DEPARTMENT OF TRANSPORTATION
National Highway Traffic Safety Administration
Docket No. NHTSA-2010-0053
Visual-Manual NHTSA Driver Distraction Guidelines
For In-Vehicle Electronic Devices

ACTION: Notice of Federal guidelines.

Figure 2: Drawing of Slide Presented by Toyota at NHTSA Technical Workshop¹³⁶

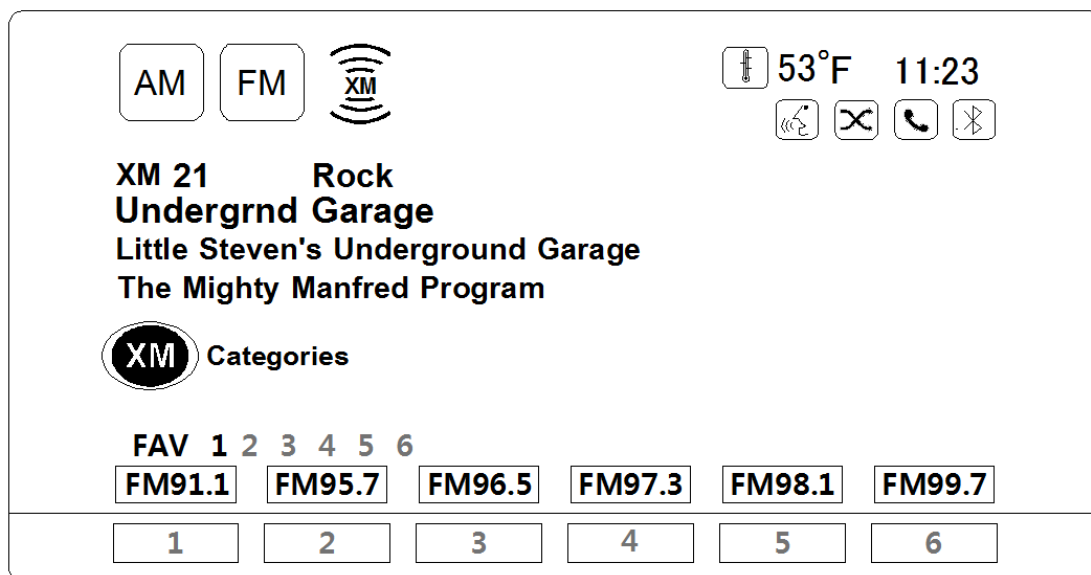
(See Figure 2 below). He then asked:

How do we apply the 30-character limit to this display? If it means a whole display can only contain 30 characters, if you look at just the six preset buttons, each preset button has five characters. So once we have the presets presented to the user, we can't give them any other information about what the radio is doing. If you pick any one element within this display, you quickly exceed a 30-character limit ...¹³⁵

Where should the 30 character limit be applied to this display?

Mr. Foley then pointed out that the information conveyed by this display is easily grasped and that drivers do not have to read each individual letter to understand what is being transmitted by this display.
